Notice of Allowability	Application No.	Applicant(s)	(m)	
	10/758,288	YAMASHITA ET AL.		
	Examiner	Art Unit		
	Jeffrey L. Sterrett	2838		
The MAILING DATE of this communication appeal All claims being allowable, PROSECUTION ON THE MERITS IS herewith (or previously mailed), a Notice of Allowance (PTOL-85) NOTICE OF ALLOWABILITY IS NOT A GRANT OF PATENT RIOF of the Office or upon petition by the applicant. See 37 CFR 1.313	(OR REMAINS) CLOSED in or other appropriate commu IGHTS. This application is s	this application. If not included inication will be mailed in due could	rse. THIS

EXAMINER'S AMENDMENT

The title has been changed to -- SWITCHING POWER SUPPLY WITH NOVEL COMMON MODE FILTER ARRANGEMENT ---

Mikihiro YAMASHITA, et al. SWITCHING POWER SUPPLY DEVICE Q79286 January 15, 2004 Darryl Mexic (202) 293-7060 1 of 5

FIG. 1

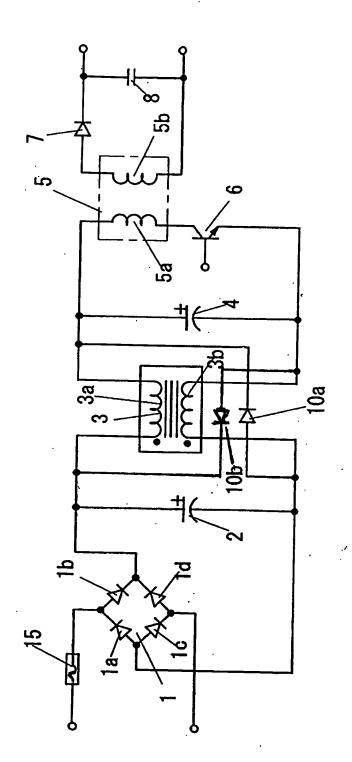
Note attached copies of the drawings corrected in red. In short: box 15 should be amended to show a fuse symbol in figures 1-4, the dashed lines associated with diodes 10b and capacitors 11b and 12b should be amended to be solid lines in figures 1-4, box 106 should be amended with the label "DC/DC converter" in figure 5, and figure 5 should be amended to included the label "PRIOR ART".
